ADDENDUM NO. 1

5th Street & Walnut St. Streetscape Improvements

Model Construction
1826 Race Street
Cincinnati, OH 45202

PROP. REPLACEMENT BASEPLATE FOR ODOT POLE #2 SECTION A-A

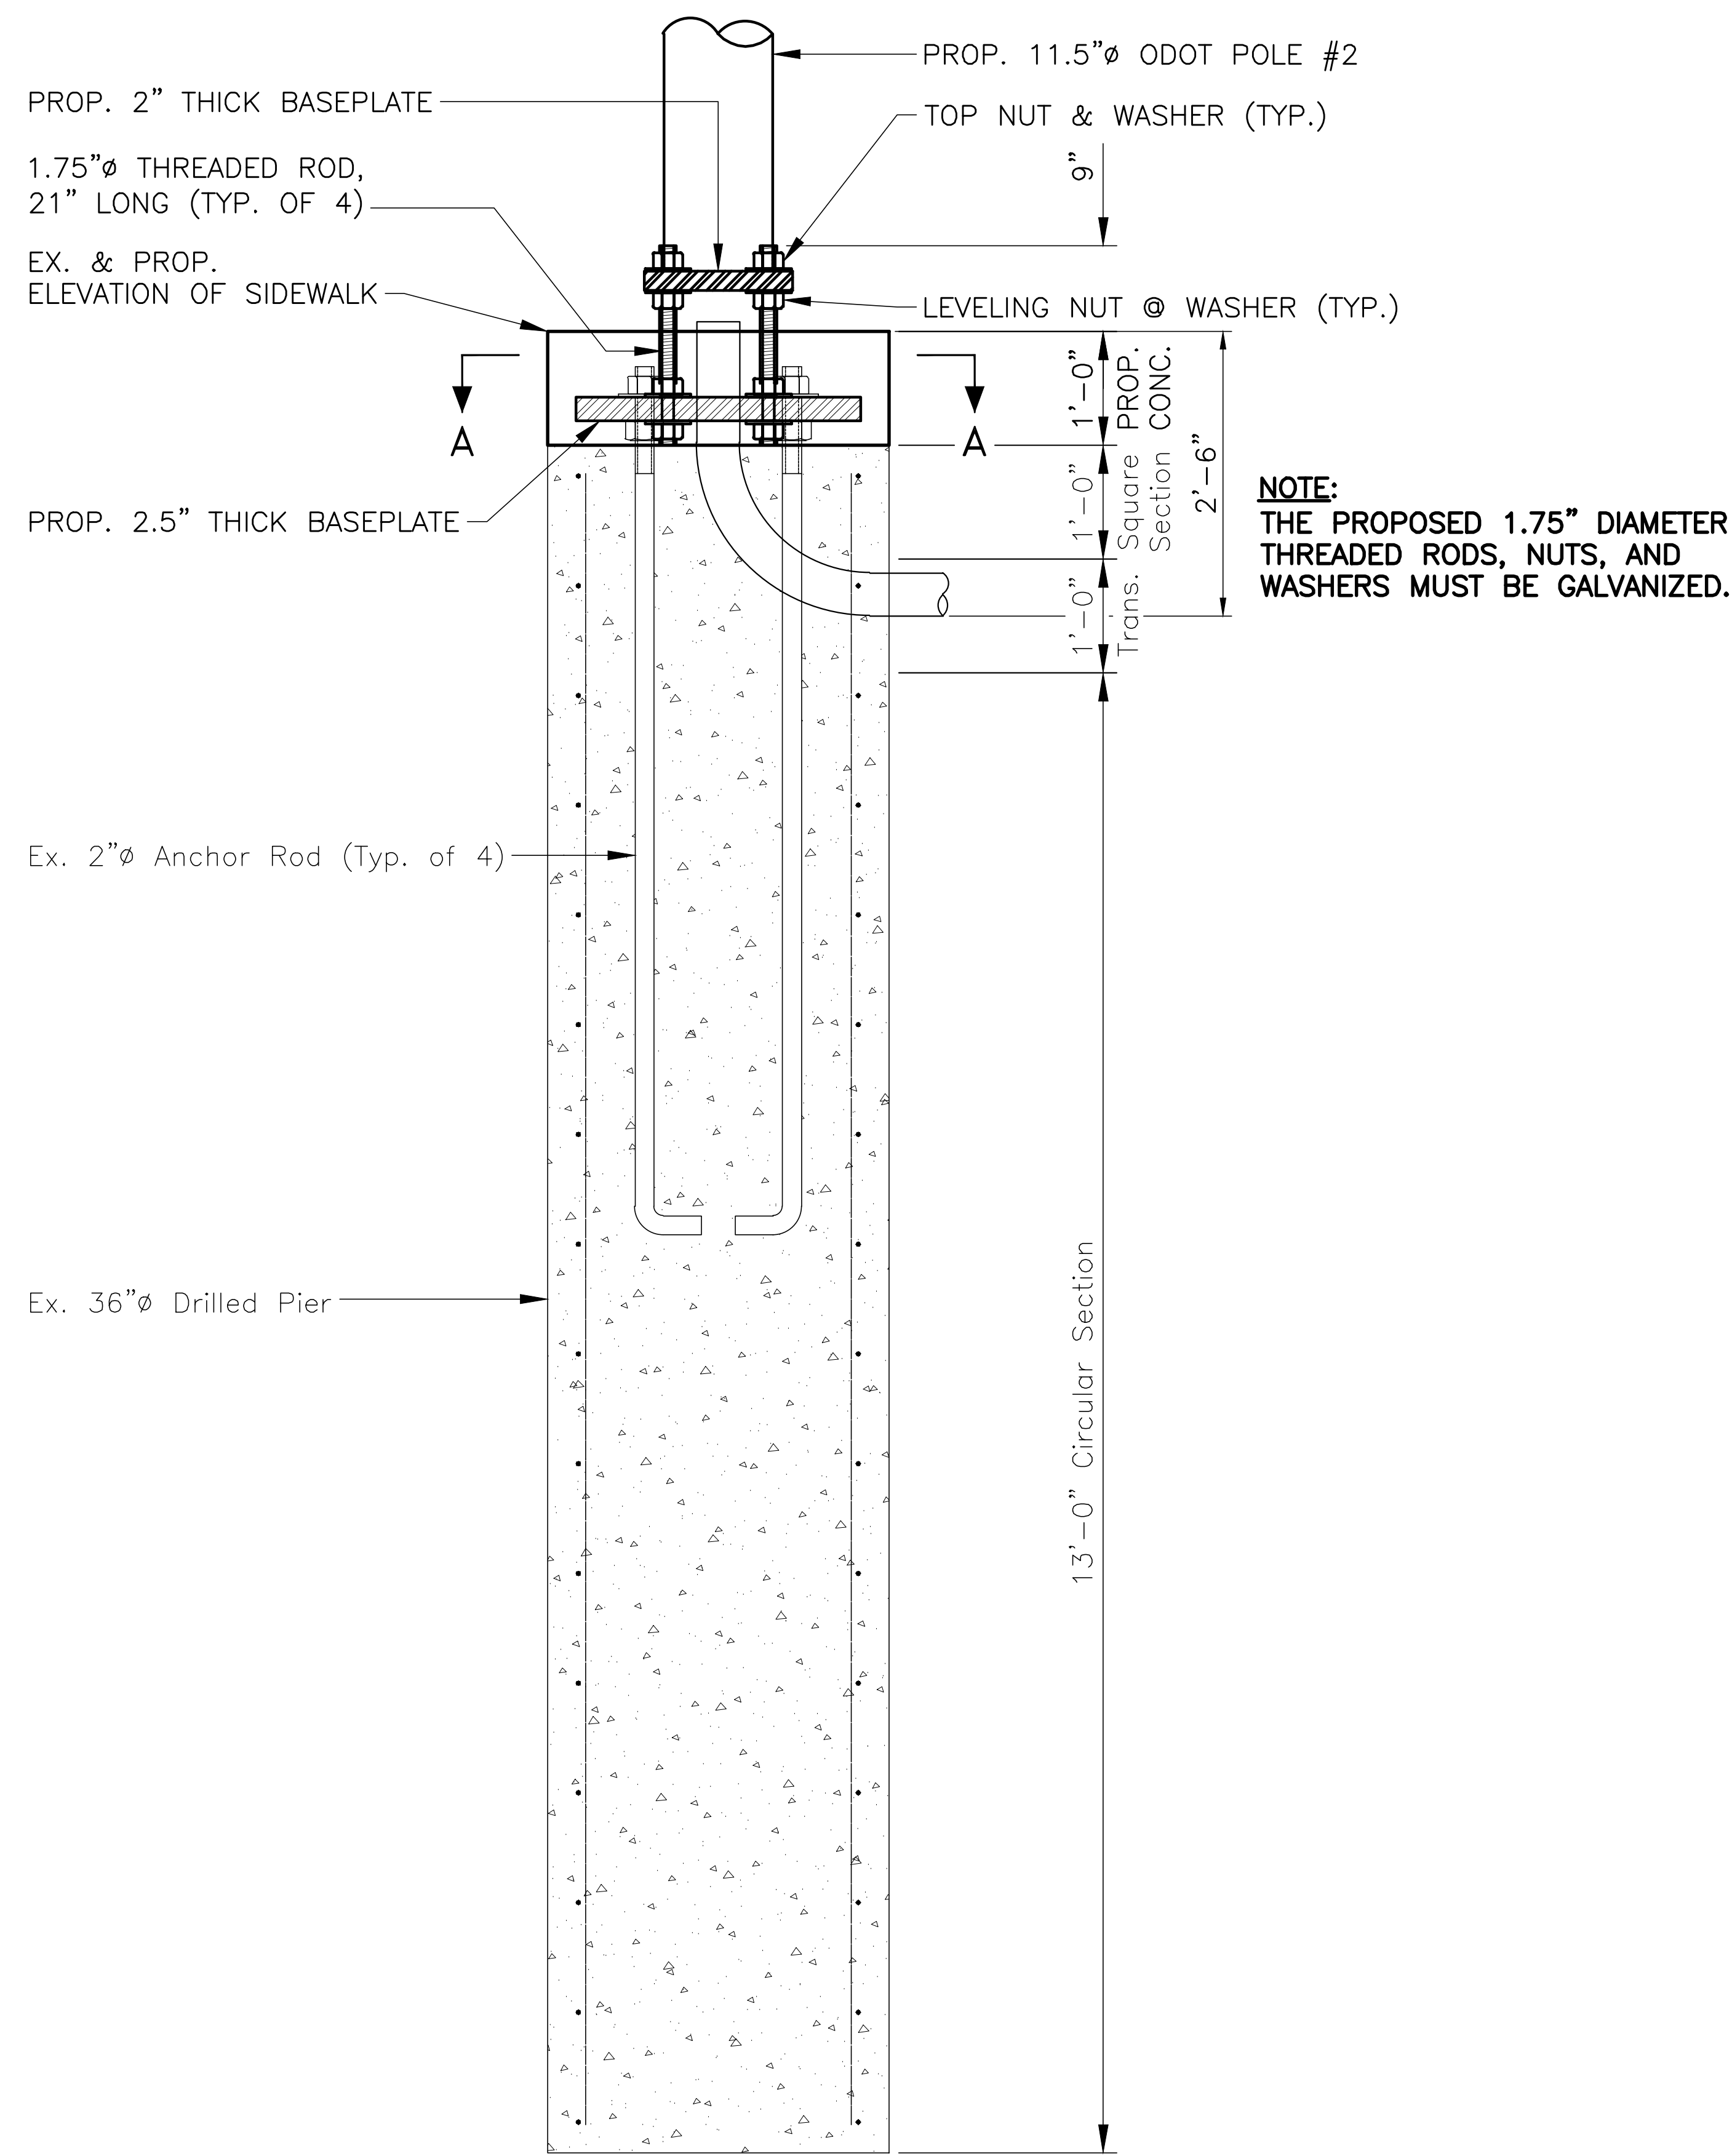
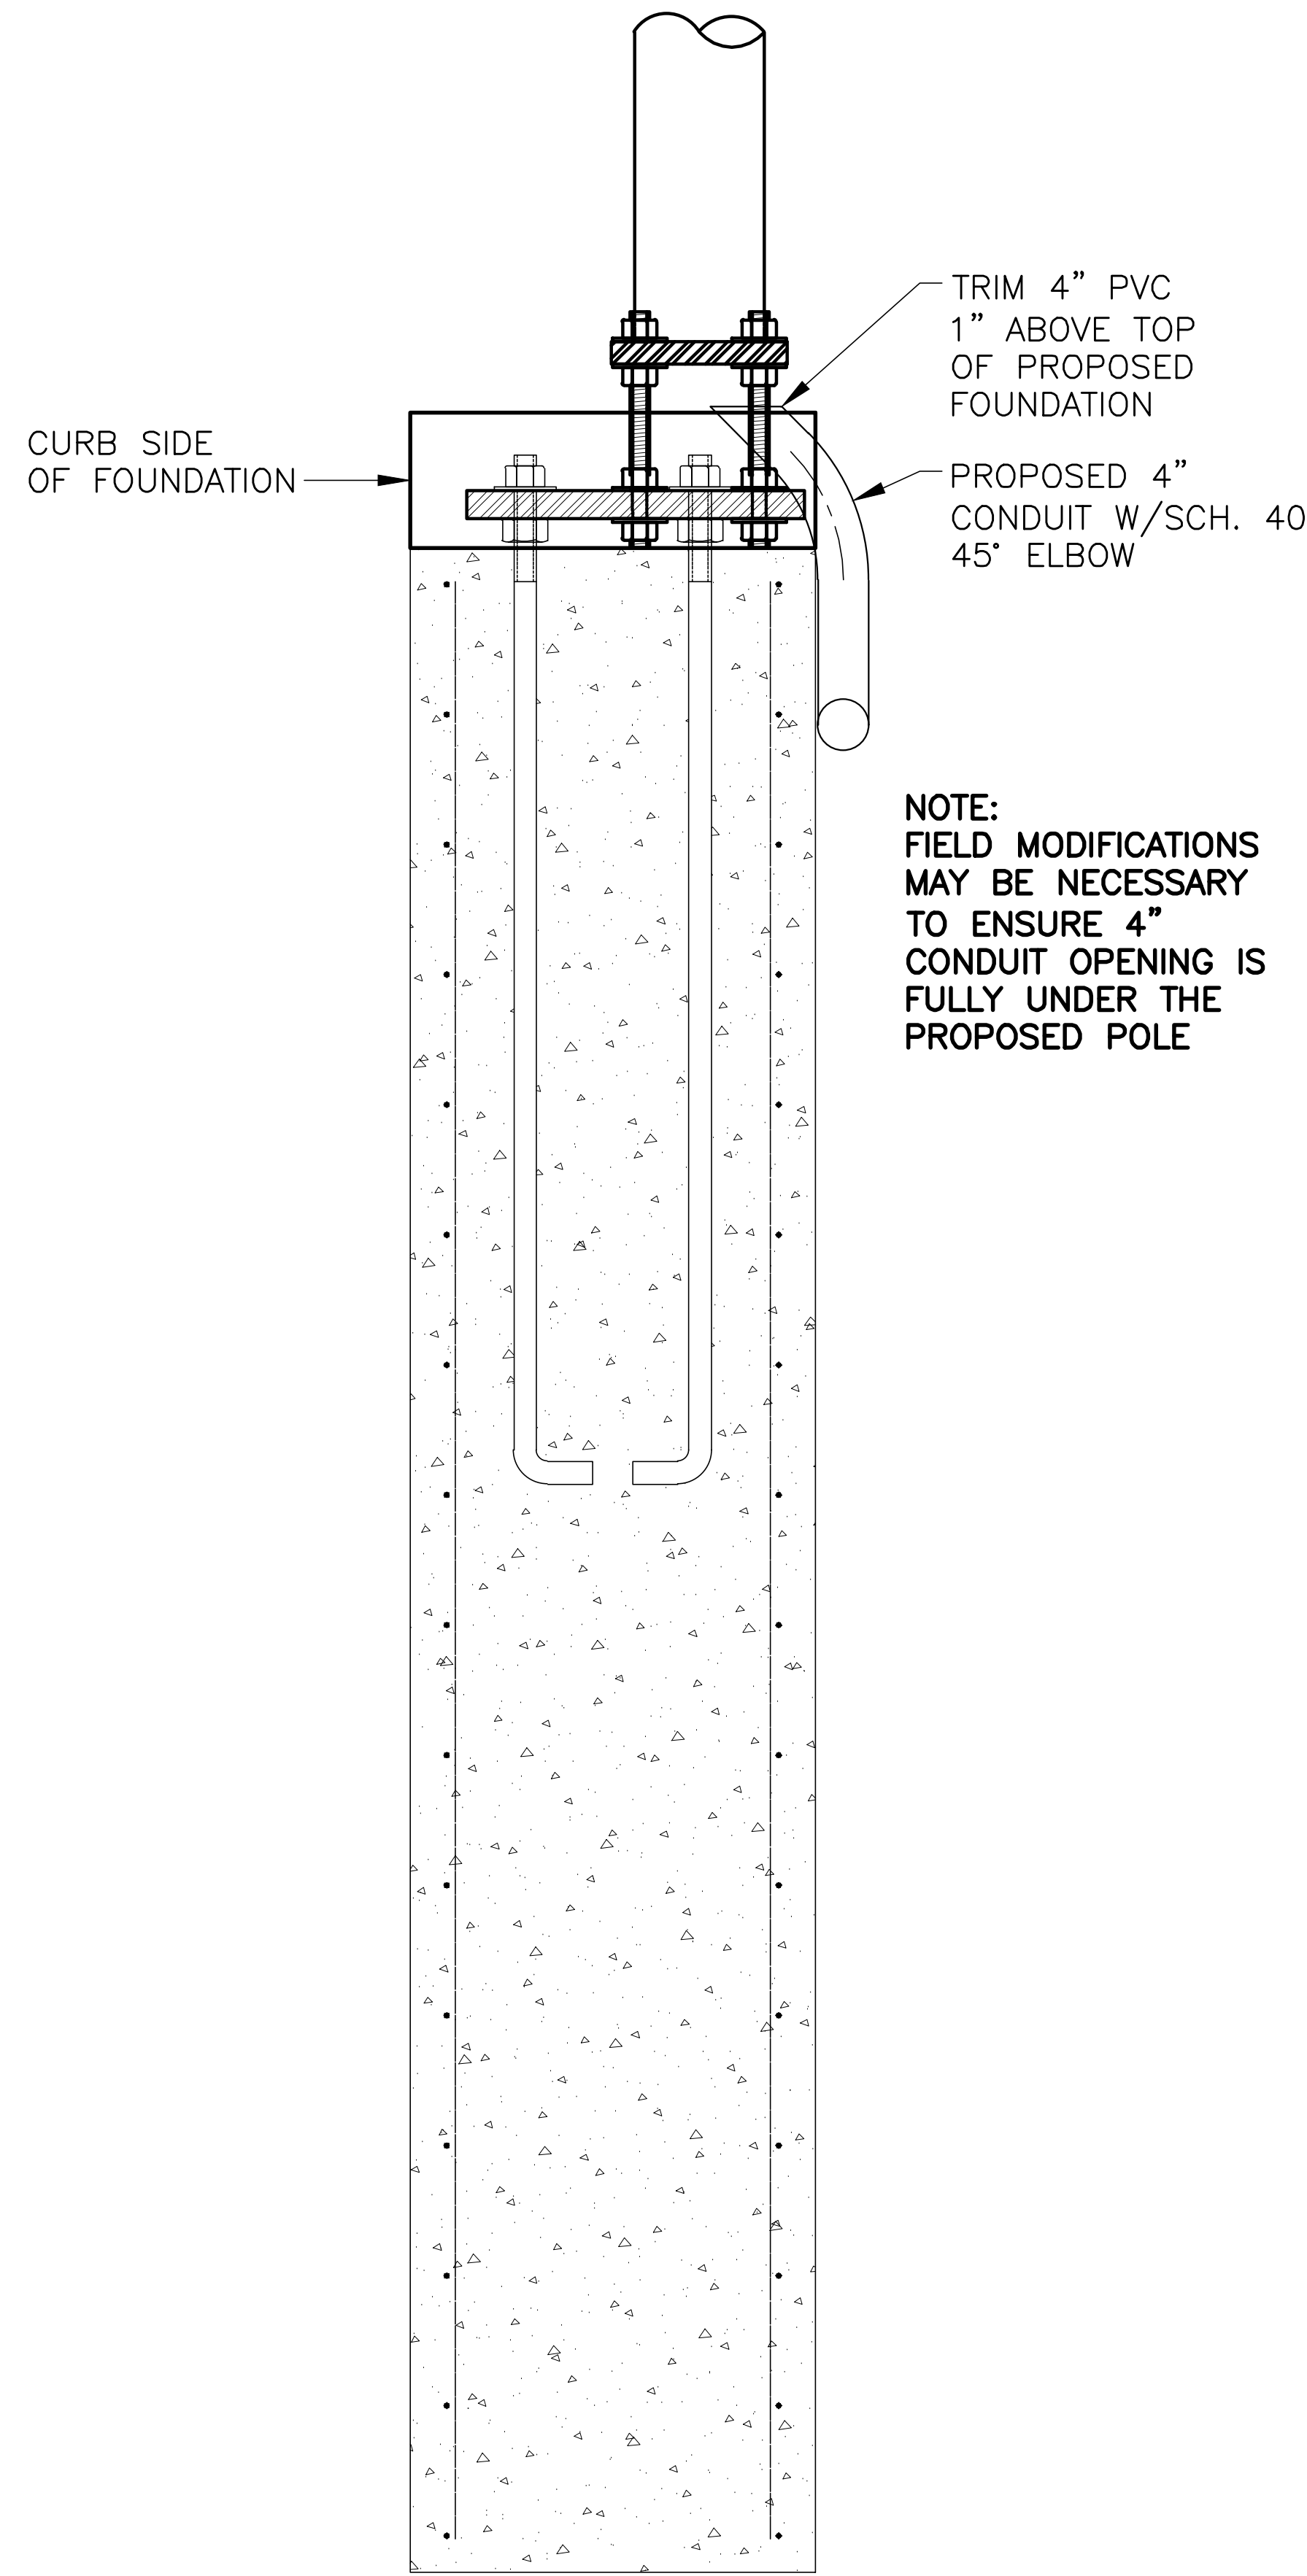
Install the new 2.5" thick baseplate with the pre-installed 1.7 diameter anchor rods attached. Anchor rods must extend the indicated length toward the top of the plate.

In the field, set the 2.5" thick plate over the existing bolts. Check tightness of the new nuts attaching the replacement rods.
